Franklin Municipal Planning Commission

Thursday, February 26, 2015

DOWNS BLVD SUBDIVISION, SITE PLAN, SECTION 1, LOT 20
FRANKLIN MUNICIPAL PLANNING COMMISSION 2/26/15

SITE
LAYOUT
PLAN

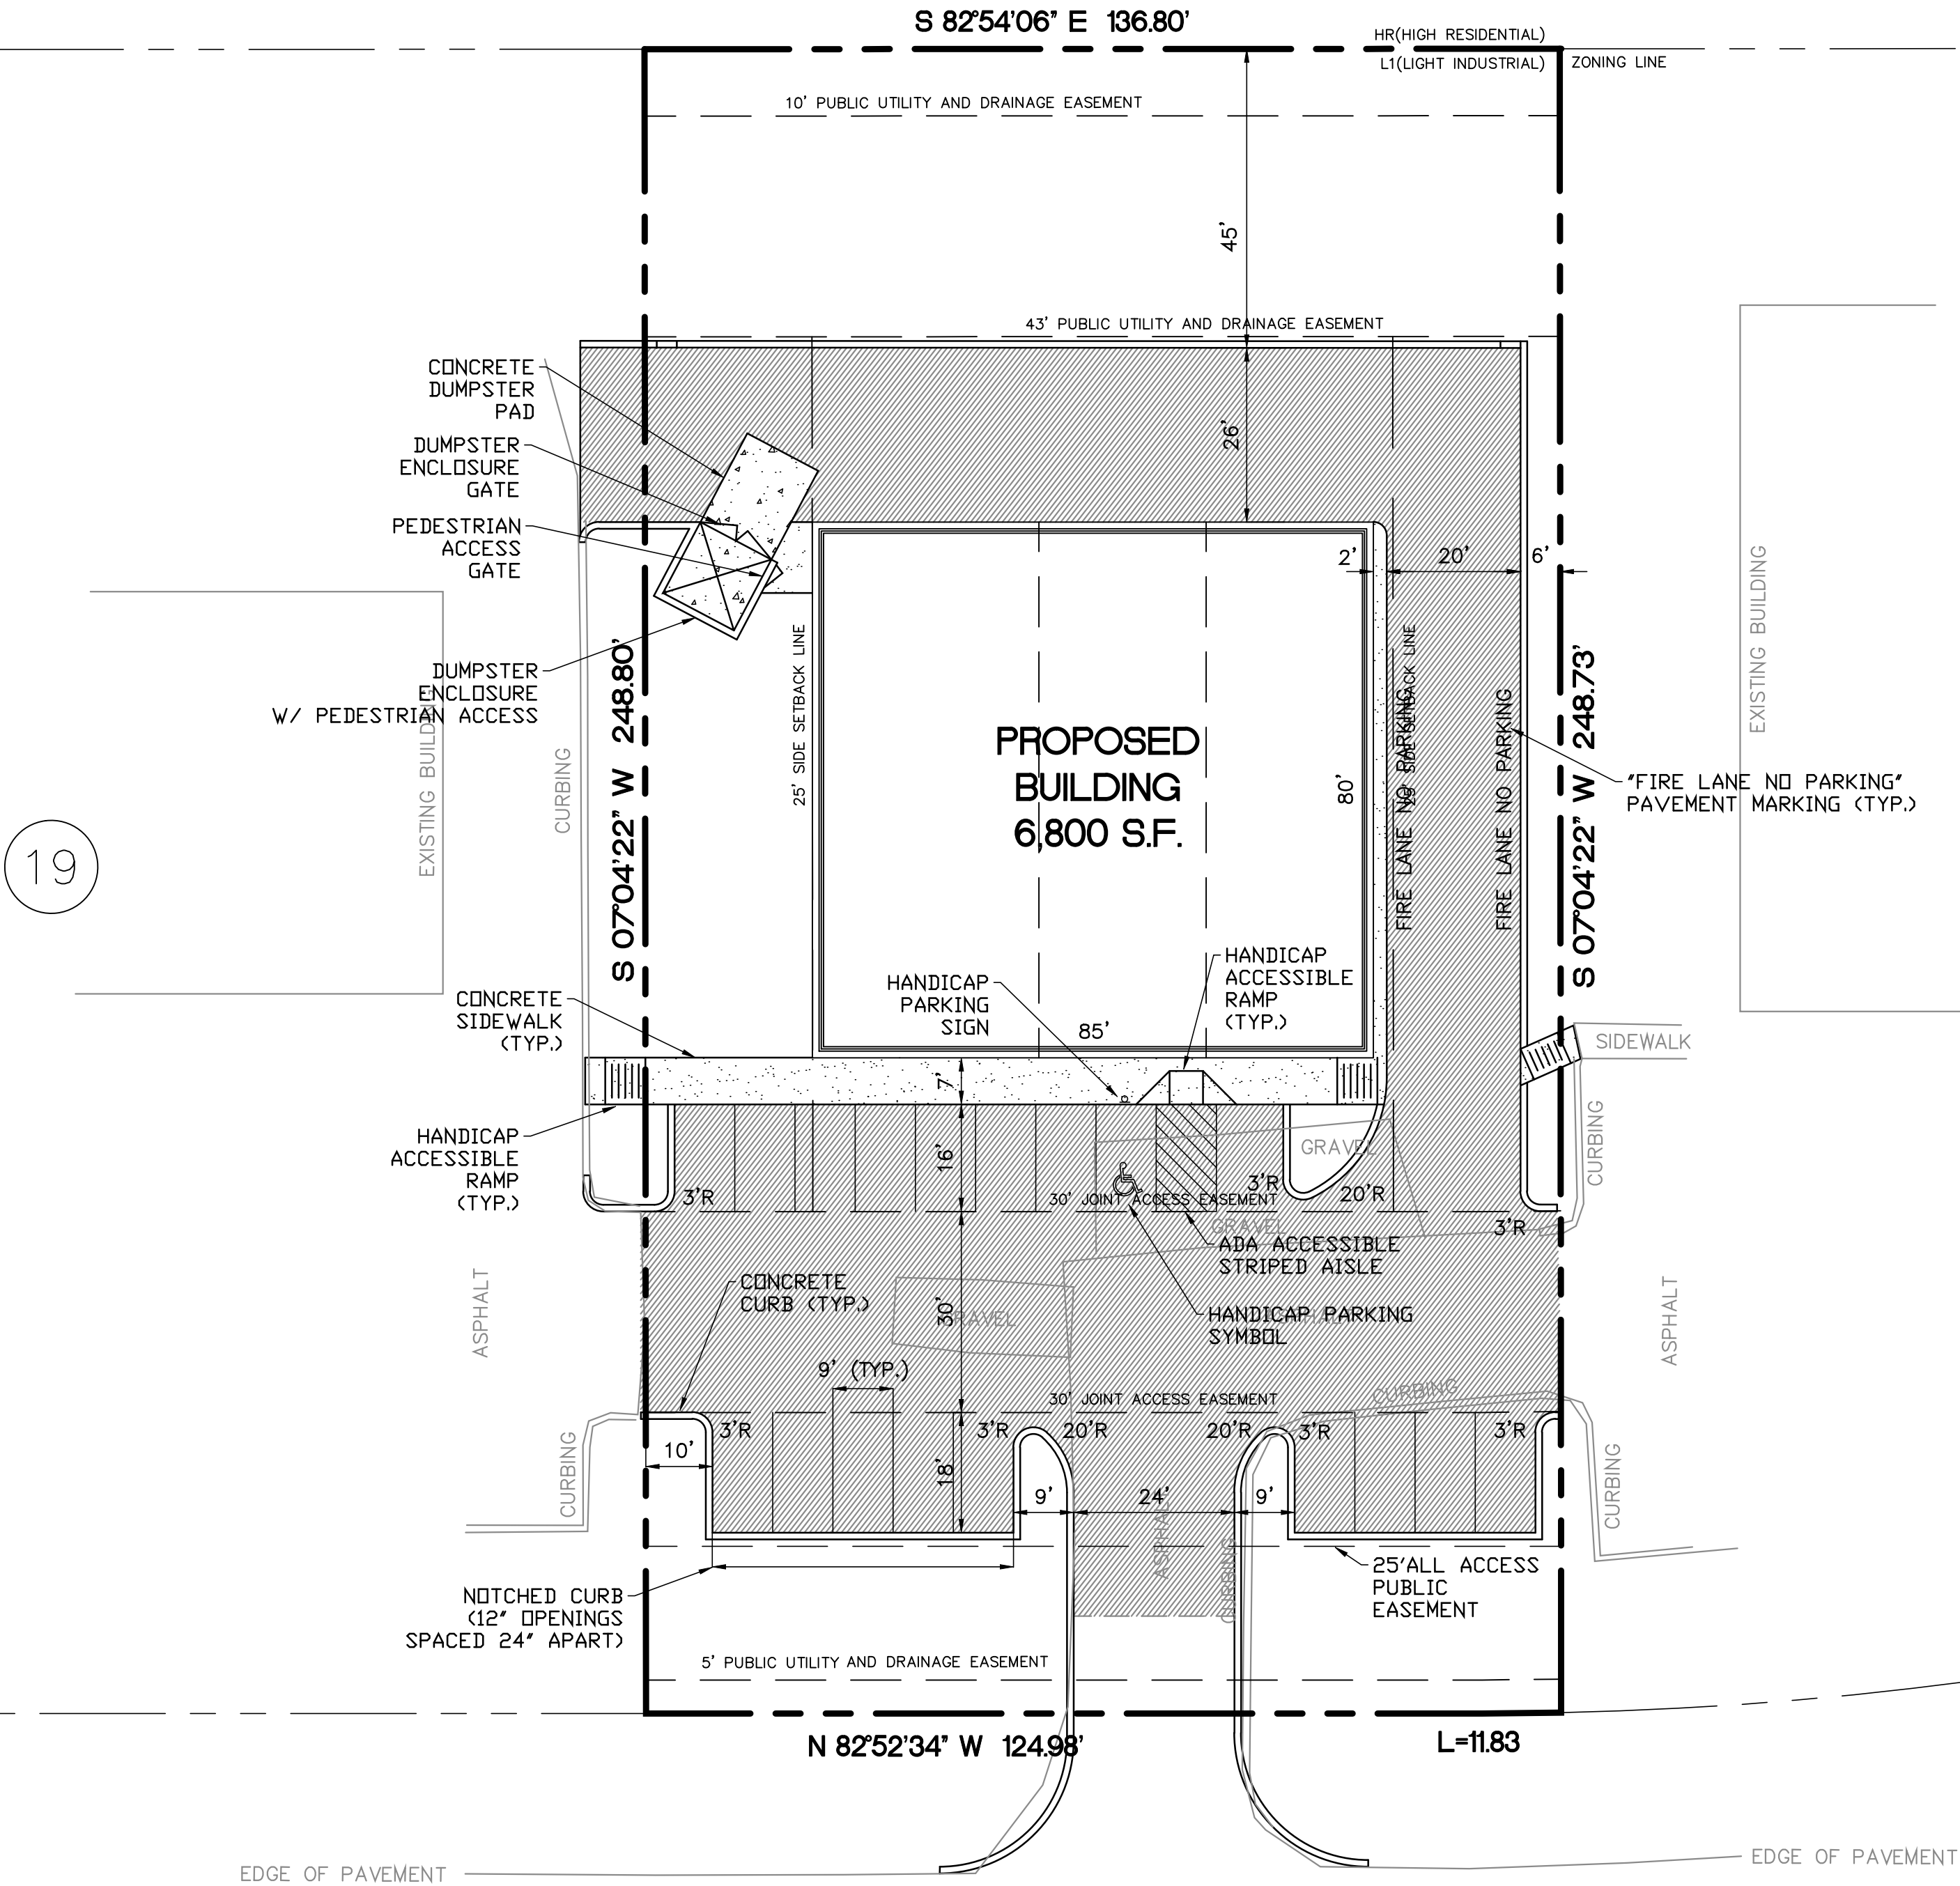
- On the site plan, show and label the building setback lines.

- Show and label the proposed retaining wall on the site plan. Label top and bottom of wall elevations. Provide construction details for all walls showing that the exterior/visible material is required to match the building.

- Provide the parking calculations on the site plan. Parking is to be provided based on the office space and the warehouse space.

- Show and label the required striped loading area of 12' x 25' next to the building. Signage is required to show no parking in this area.

SITE
UTILITY
PLAN

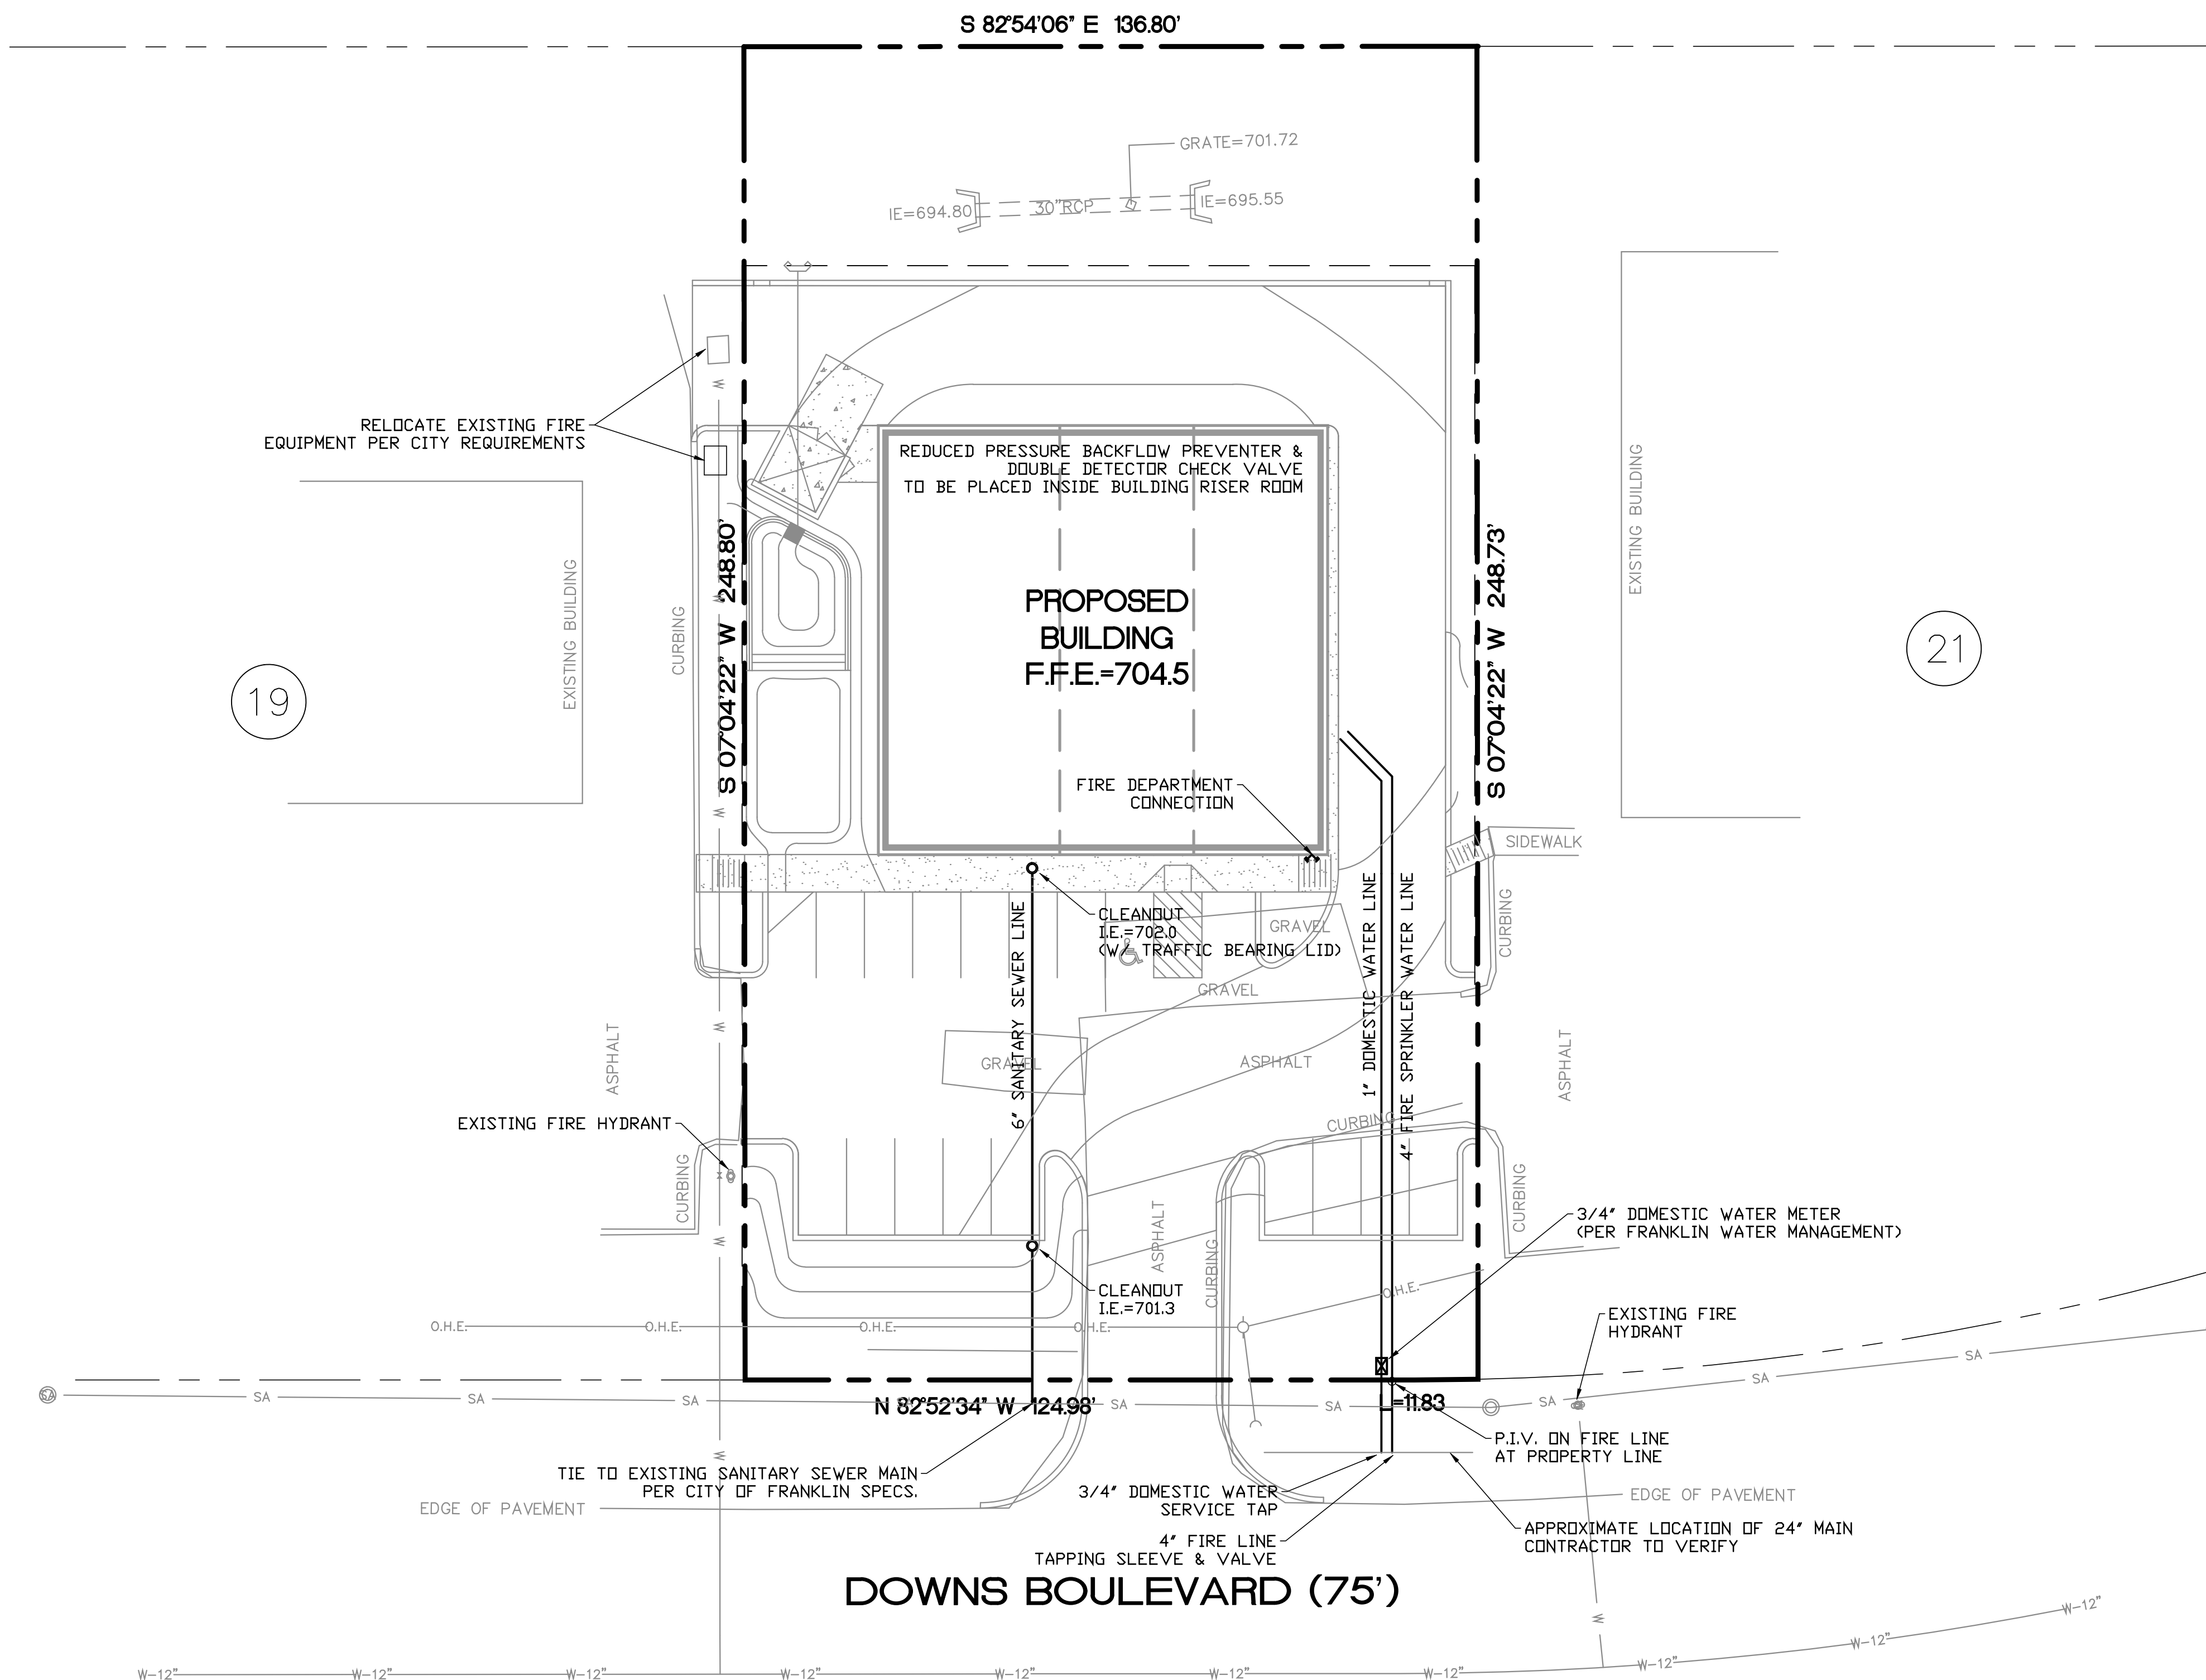
- This is a new comment. The water services must make only one tap at the main line. Tee the domestic service off of the fire service line. Provide 10 feet of clearance from the service tee to the sewer main.

- Applicant addressed comment, but the water management department did not clarify what main line the 3/4 water tap should be shown. The 3/4 water tap shall be shown on the 4" fire line main prior to the PIV.

- Applicant did not address comment, Applicant shall show the location of the 12" reclaim water line. The city of Franklin is not a member of TN one call applicant shall contact the water management department to locate all utilities on property.

- Applicant has a note on utility plan to relocate existing fire equipment per city requirements applicant shall clarify note. applicant may contact water management for questions.

BIORETENTION AREA CROSS-SECTION

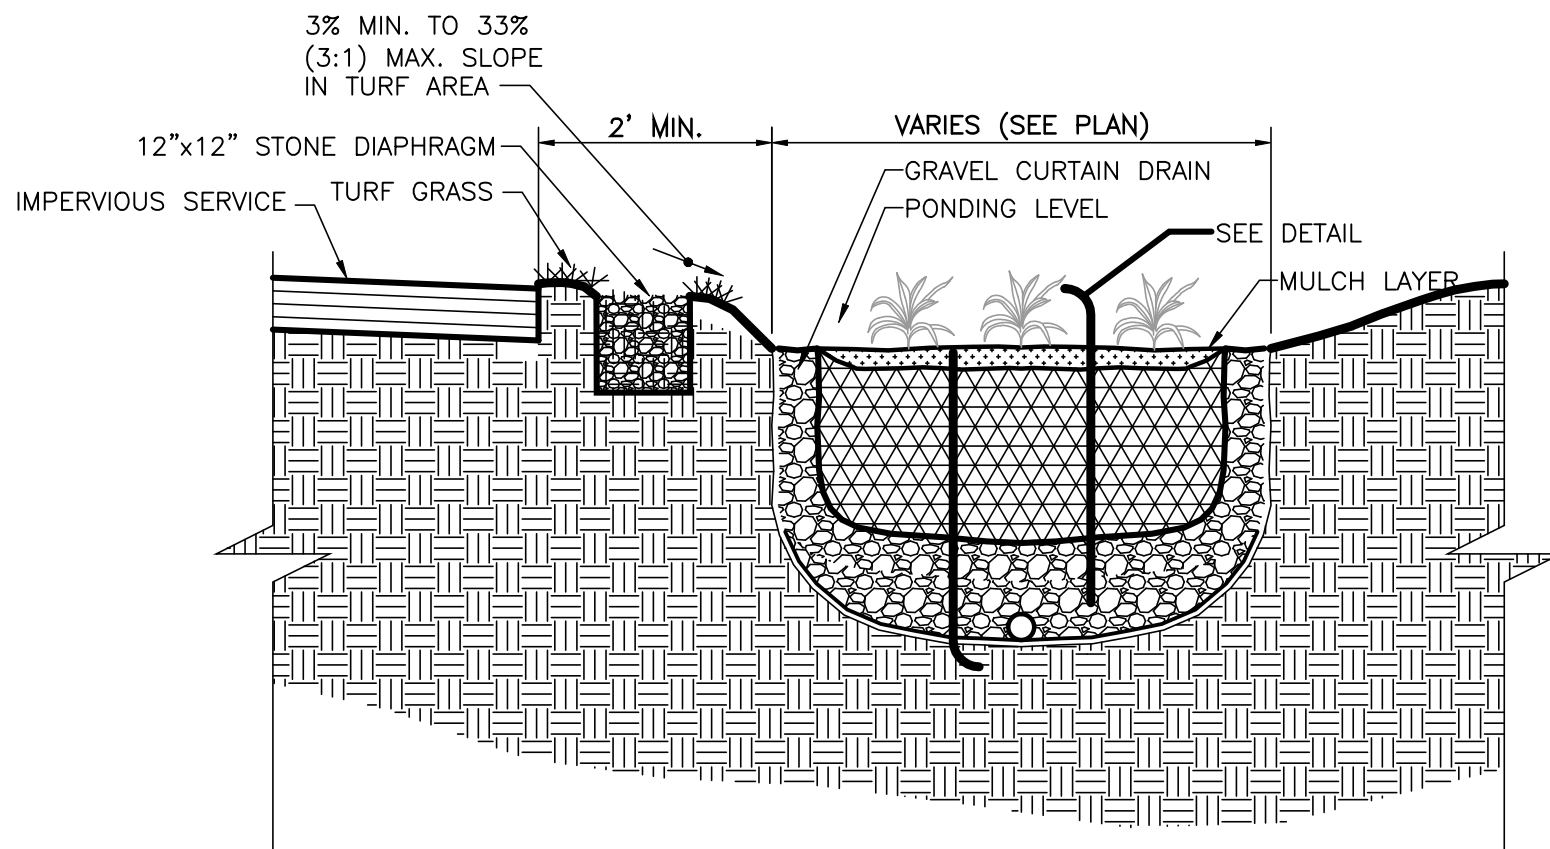
- The river stone ribbon could be reduced to a smaller width and depth if desired. Too much rock could add weight that overtime could reduce infiltration of amended soils by compaction. Plants should encompass the entire bioretention area to provide evapotranspiration rates and treatment throughout the bioretention area.

- A stone trench is called for in the bioretention cross section but does not appear on the grading/drainage plans. Please specify or include this on the drawings.
